Staff Report

Re: PLNSUB2017-00370 & PLNPCM2017-00525 – Centro Civico Senior Housing – Planned Development & Conditional Building and Site Design Review

PROPERTY ADDRESS: 145 South 600 West
PARCEL ID: 15-01-108-035-0000
MASTER PLAN: Downtown Master Plan
ZONING DISTRICT: G-MU – Gateway Mixed Use Zoning District

ATTACHMENT B: SITE PLAN

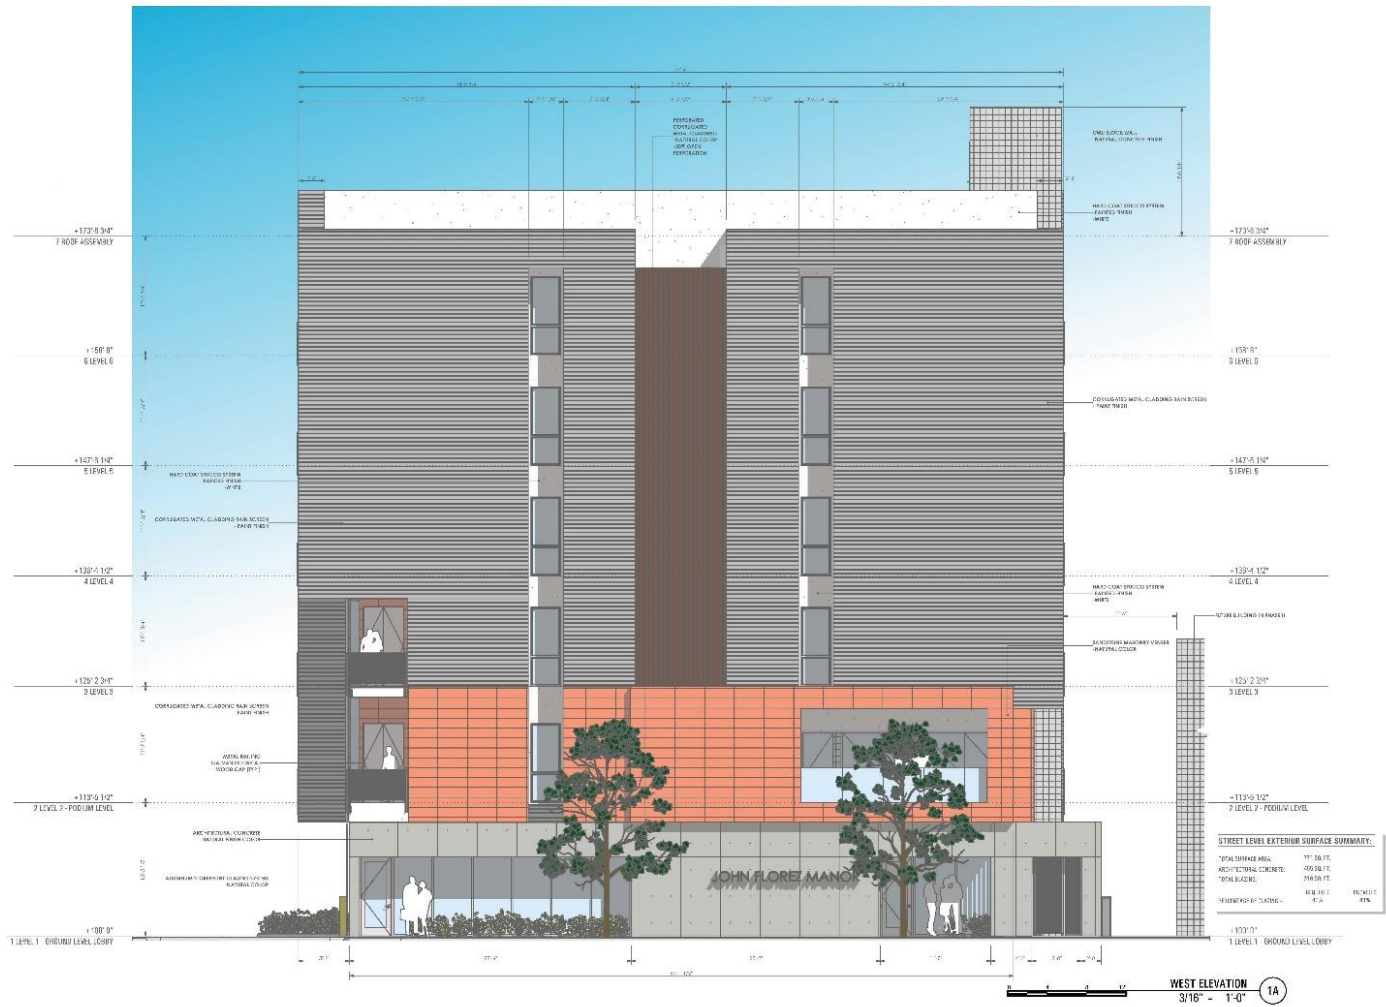
The Transportation Division isn't opposed to the proposed planned development however it is difficult for us to provide much comment until more detailed designs are provided showing information that was indicated in the DRT. For example on the architectural site plan without more dimensions it is impossible to tell if they are providing adequate space for vehicular circulation, it appears a vehicle parked in the ADA space has no turn around area, and it appears a 10'x10' sight triangle is not provided where the driveway and sidewalk intersection.

Staff Note: A revised circulation was routed to Transportation for review on August 7, 2017. As of the date of this report, no additional comments in regard to the revised circulation plan have been received by Planning Staff.

Revised west elevation showing additional dimensions.

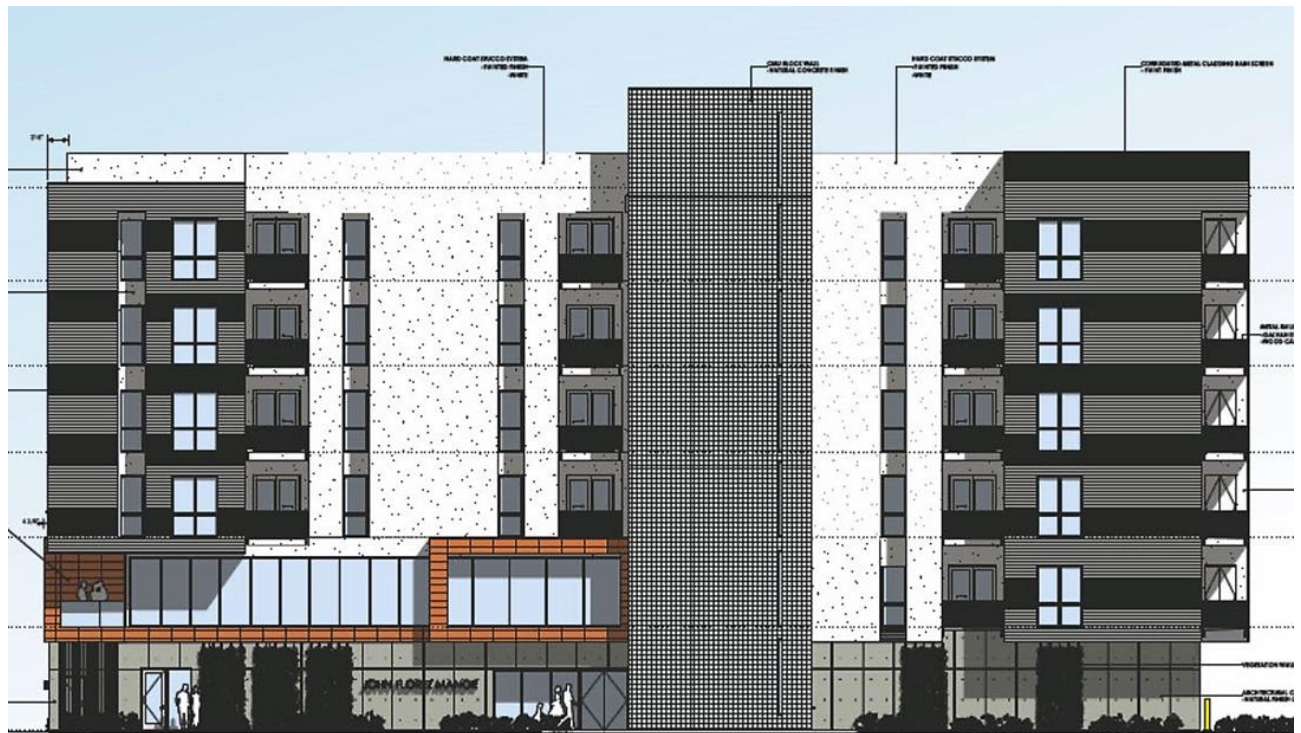
Issue 2: Maximum Length of Blank Walls

On the public street facing elevation of the building, there is a proposed blank wall section that measures 25 feet long. The Gateway Districts Urban Design Standards (21A.31.010.P.3.a.3, Salt Lake City Zoning Ordinance) specifies the following:

- **Site Plan Details** – The Planning Commission requested that the site plan and elevations include the full building dimensions and height of the proposed building. The total length of the 600 West façade was one item that was not clear on the plans.

- **West Building Façade/Windows/Street Presence** – There was discussion and concern expressed about the lack of contrast/changes on the upper 4 floors of the west elevation. The main concern with the proposed metal surface is the monotony that it would impart. The possibility of the west elevation presenting a “shiny blank wall” with the lack of windows and metal siding was a concern. Suggestions included an exploration of varying metal colors, a mural or some other community or project art being incorporated into that elevation to break up the stark character.

Follow-up Note: The applicant has provided a revised drawing of the west elevation that incorporates additional dimensions. This drawing shows the total length of the west façade as 67 feet. The length of blank wall that is discussed in Issue 2 is show as 25-feet in length. The revised elevation is included in this report in [Attachment C](#).
